PRODUCT UPDATE

Number: #163
By: LEMO USA
Date: June 8, 2016

New Earthing Cone Design K,E,T,V and W Series

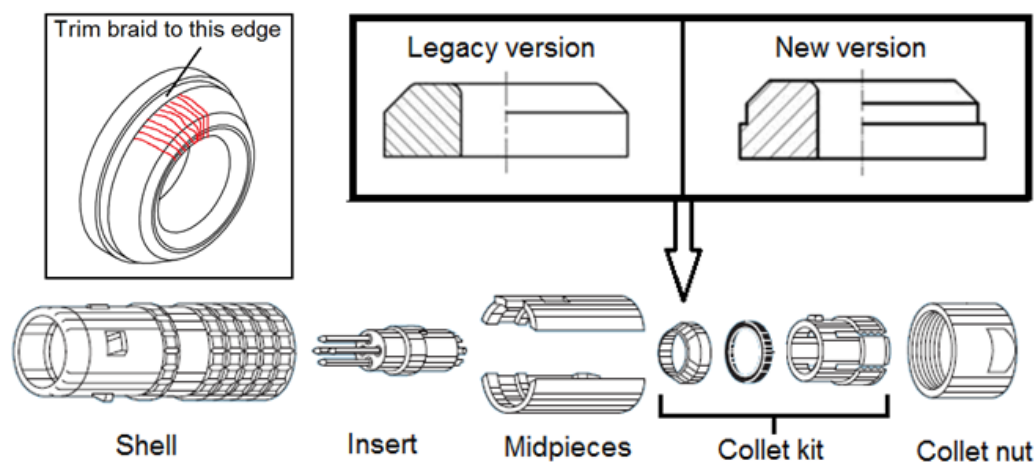
The new earthing cone design allows for improved termination of the cable shield. The shield is folded over the outside of the cone and is trimmed to the edge as shown below.
